# ONYX RANCH SOUTH FORK VALLEY WATER PROJECT

Final Environmental Impact Report  
State Clearinghouse #2018021061

Prepared for  
Rosedale-Rio Bravo Water Storage District

## Final Environmental Impact Report

**CALIFORNIA DEPARTMENT OF FISH AND WILDLIFE  
RECOMMENDED MITIGATION MONITORING AND REPORTING PROGRAM  
(MMRP)**

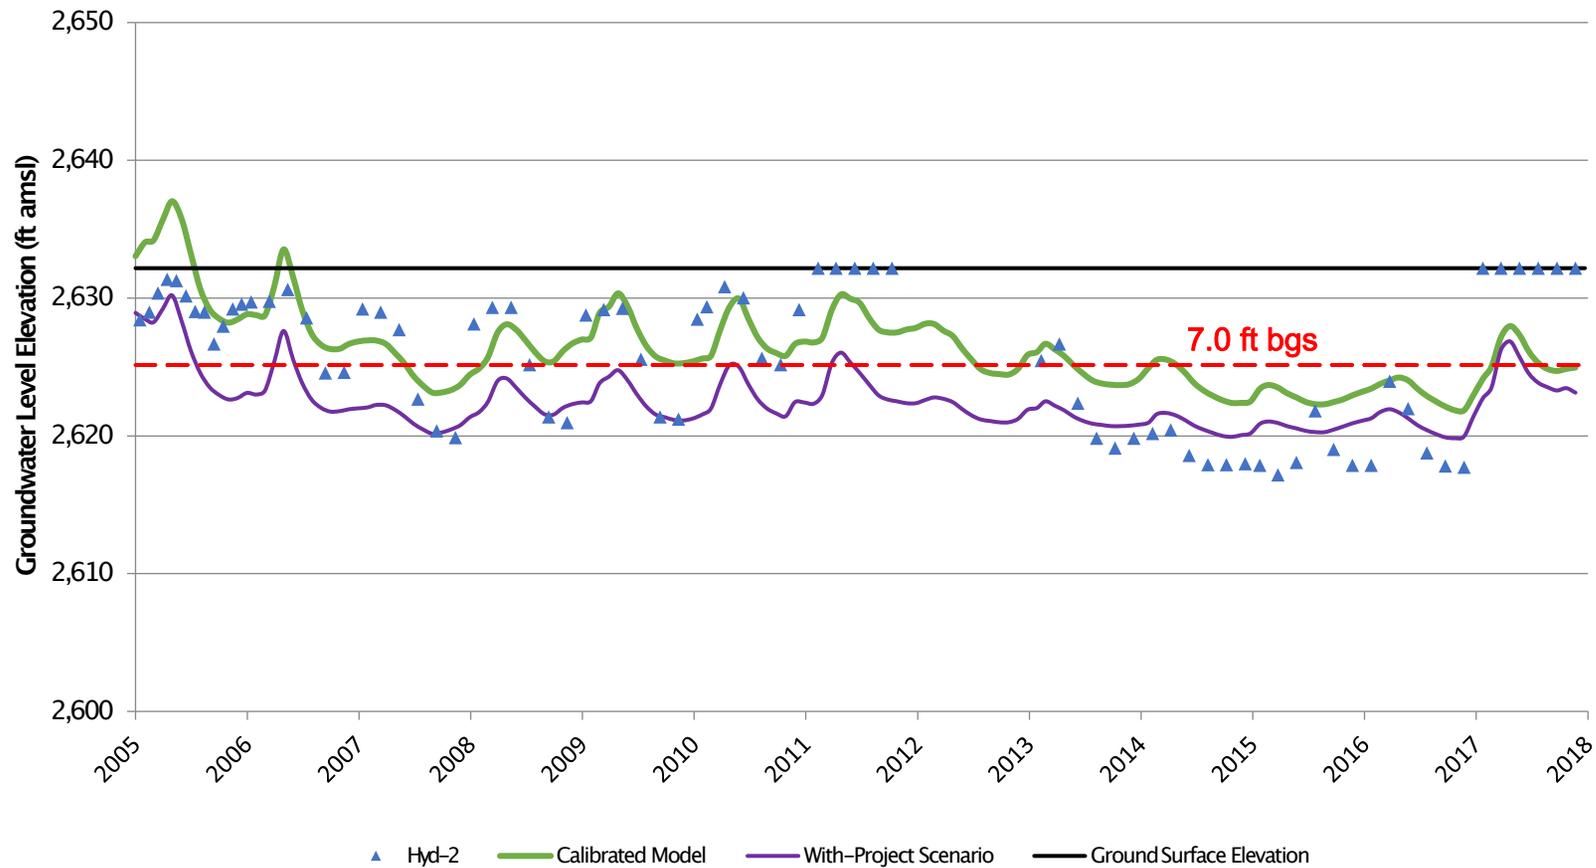
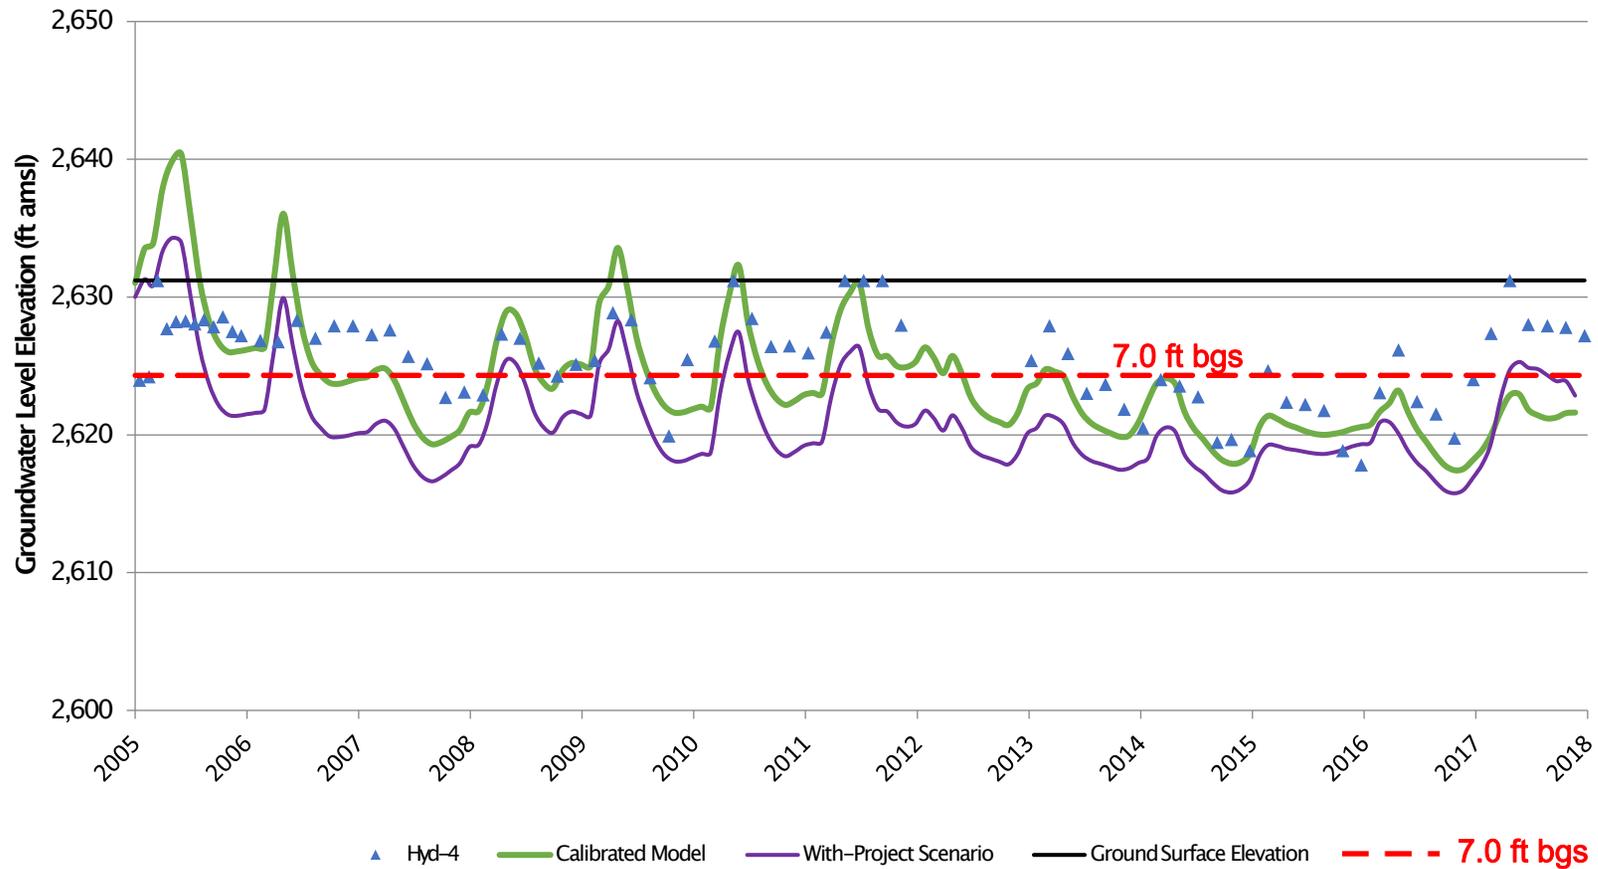
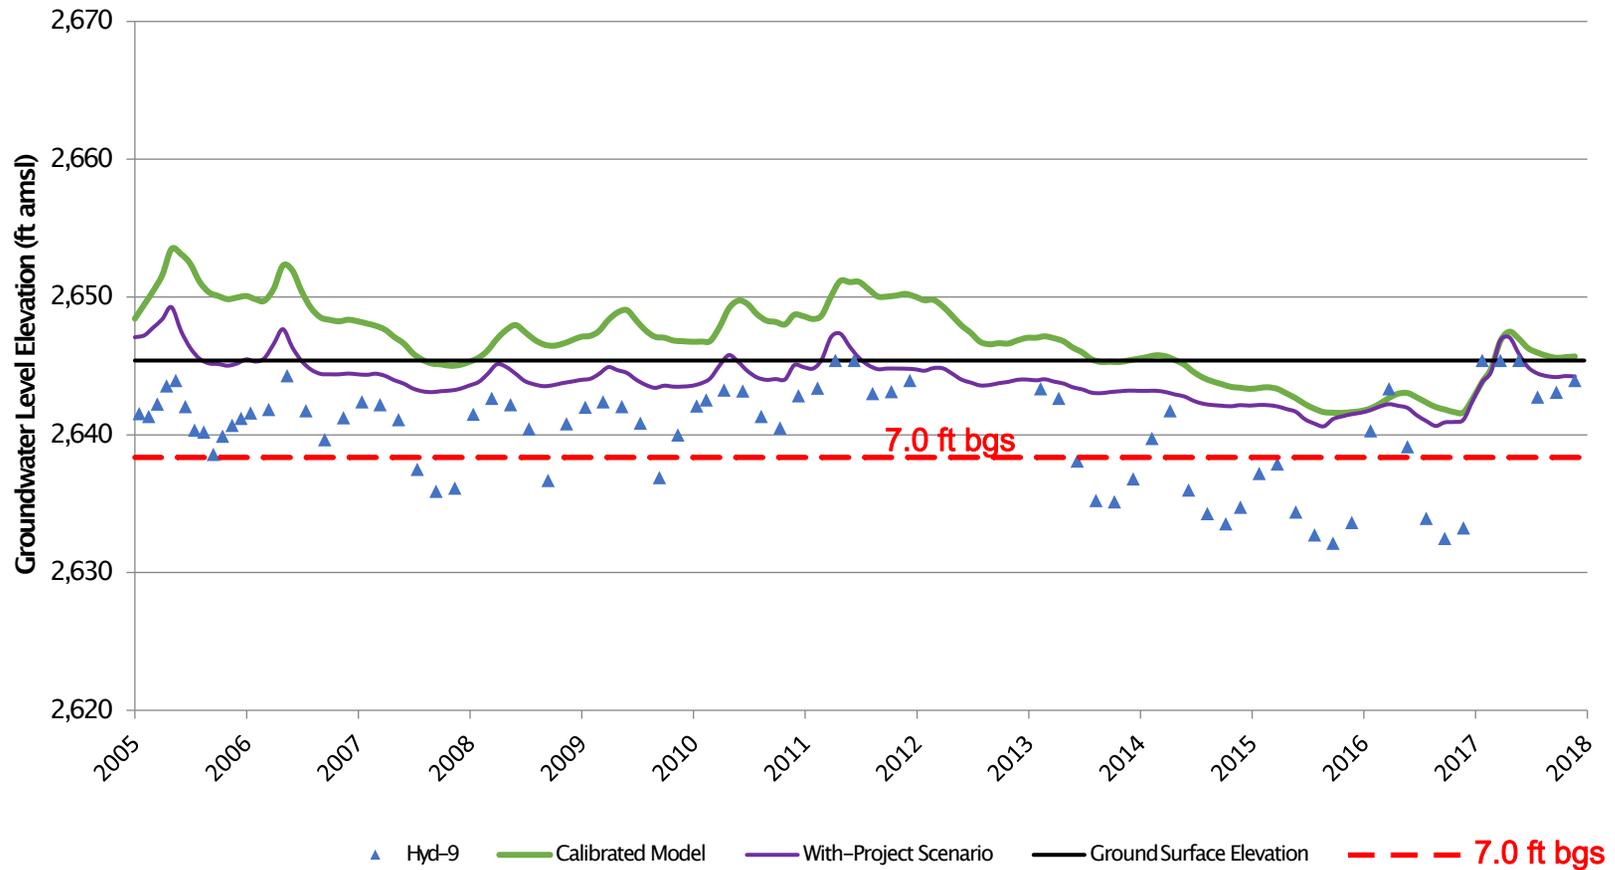
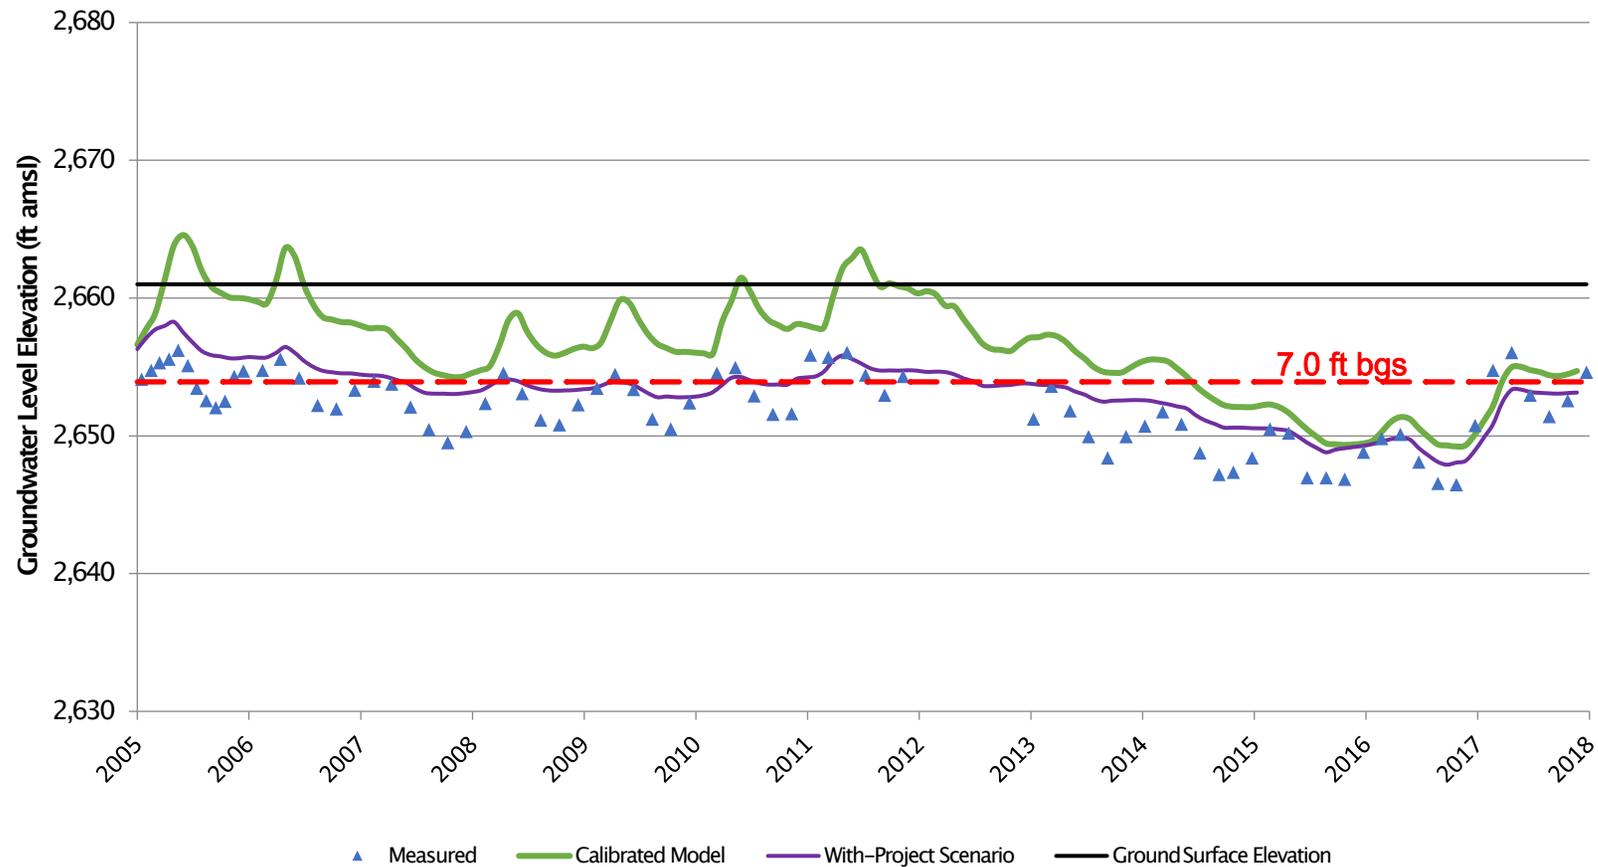
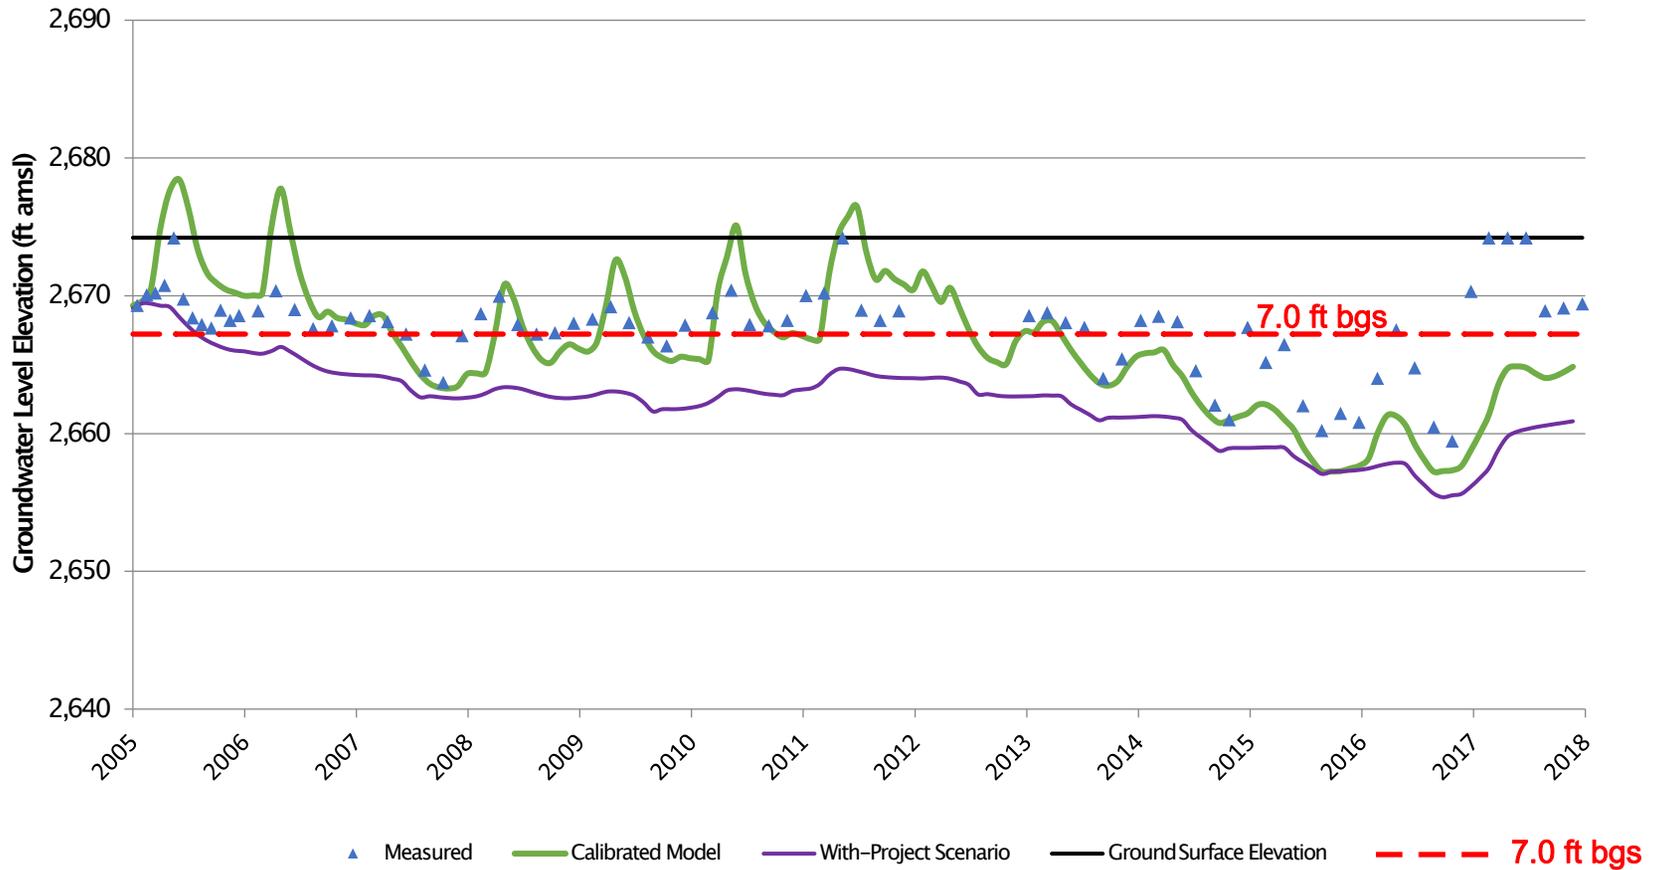
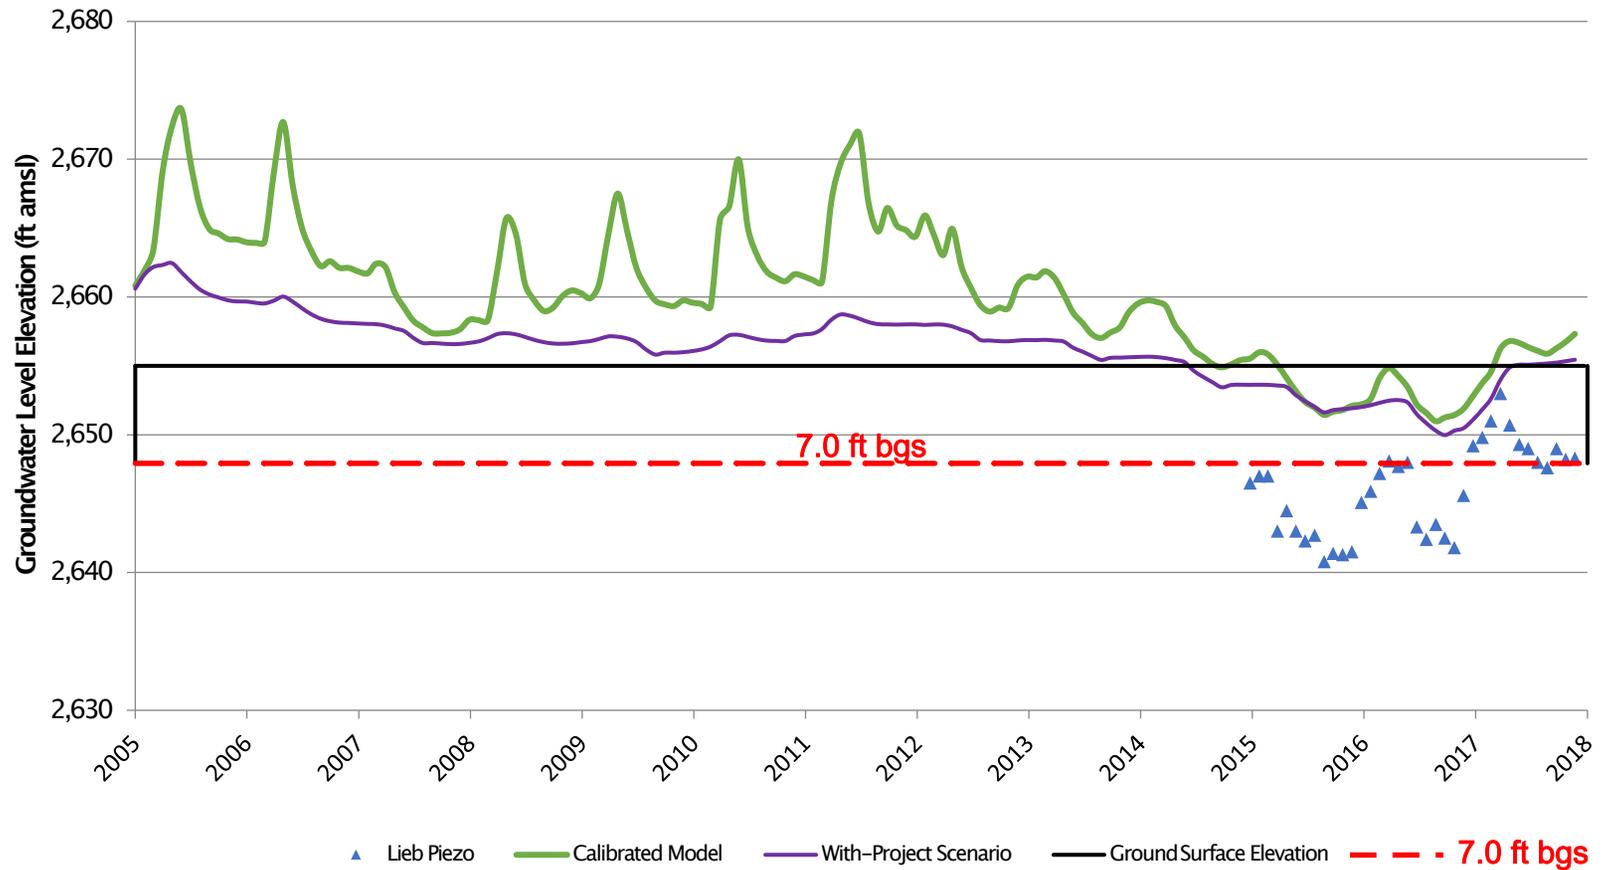
Enclosed with this letter are 11 of the hydrographs for the wells located closest to the South Fork Kern River (from DEIR Figure 3.11-6). On each of these hydrographs, CDFW has added a horizontal line at what approximates a 7-foot depth below ground surface, a depth that can be a critical threshold for preservation of groundwater dependent ecosystems (GDEs) (DEIR page 3.6-57).

The comment is noted for the record. The 11 hydrographs in the attachment to the comment letter show actual measured groundwater levels between 2005 and 2018 at the wells located closest to the South Fork of the Kern River as shown in Figure 3.11-6 of the Draft EIR. The 11 hydrographs show that under existing conditions groundwater levels vary in space and time and have been measured both above and below the 7.0-foot depth below ground surface (bgs), the red line for which has been added by CDFW. As shown by the green lines for the Calibrated Model and the purple lines for the With-Project Scenario, the proposed project would not alter these existing conditions, and groundwater elevations would continue to fluctuate above and below the 7.0-foot depth bgs. It is noted that model results more reliably show relative changes in groundwater

- The 15.6-foot modeled groundwater decrease would occur at the Nicoll Field – Old Ag Well, shown in the Draft EIR, Figure 3.11-6 on page 6.11-32, and would not occur throughout the entire Kern River Valley Groundwater Basin. Decreases in groundwater levels in all other areas would be less. Note that groundwater levels would increase in the area closer to Isabella Reservoir as shown in both Figure 3.11-5 on page 6.11-31 (dry season low groundwater levels) and Figure 3.11-6 (wet season high groundwater levels).

**Root depth thresholds:** While some literature suggests Fremont cottonwood trees are known to have taproots up to approximately seven feet deep, the U.S. Department of Agriculture (USDA) suggests rooting depths in mature Fremont cottonwood stands are up to 16 feet (USDA 2019). Wells HYD-2 and HYD-13 are located in the vicinity of Fremont cottonwood forest as shown in the Draft EIR in Figures 3.6-2a through 3.6-2c and Figures 3.11-5 and 3.11-6. The hydrographs for Wells HYD-2 and HYD-13, which are included in Appendix E of the Draft EIR and Revised Appendix E to this Final EIR, show that once the drought ends, groundwater levels would recover to within the 7- to 16-foot depth interval. Similarly, Wells HYD-1, HYD-4, HYD-9, HYD-11 also are located in the vicinity of Fremont cottonwood forest, and hydrographs for these wells show similar trends of recovery of groundwater levels to within the 7- to 16-foot depth interval following the drought years of approximately 2014 through 2017. Wells Lieb Piezo and Mills S are located on the edge of Fremont cottonwood forest and agricultural fields, and hydrographs for these wells also show similar trends of groundwater level recovery (see Revised Appendix E).
